DATE: August 13, 2015

FROM: Raymond Chong, P.E., PTOE, PTP, City Traffic Engineer

Proposed Urban Transportation Plan Amendment - County Road 50

Exhibit B-Driveway Exhibit C-C.C. Deluxe Properties, Ltd. Letter

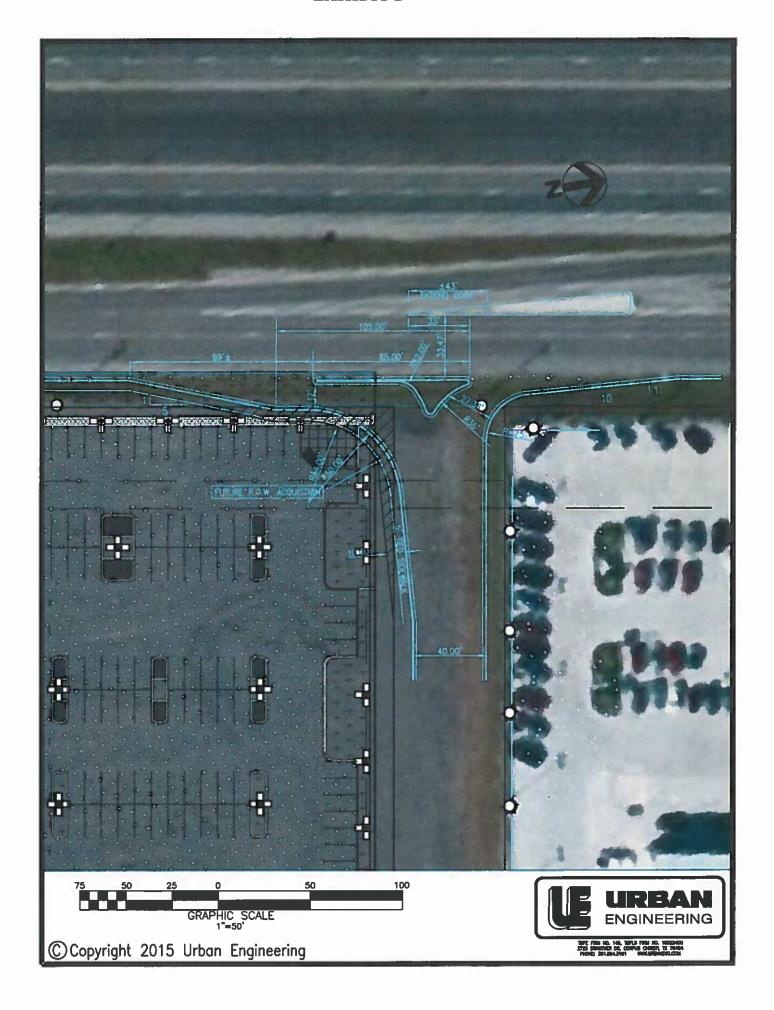
TxDOT has approved the access management concept for County Road 50 and IH 69 frontage (see attachment) for Driveway permit exhibit. The approved design requires right of way dedication and gore extension of entrance ramp. The preliminary plat must include the required right of way dedication for TxDOT.
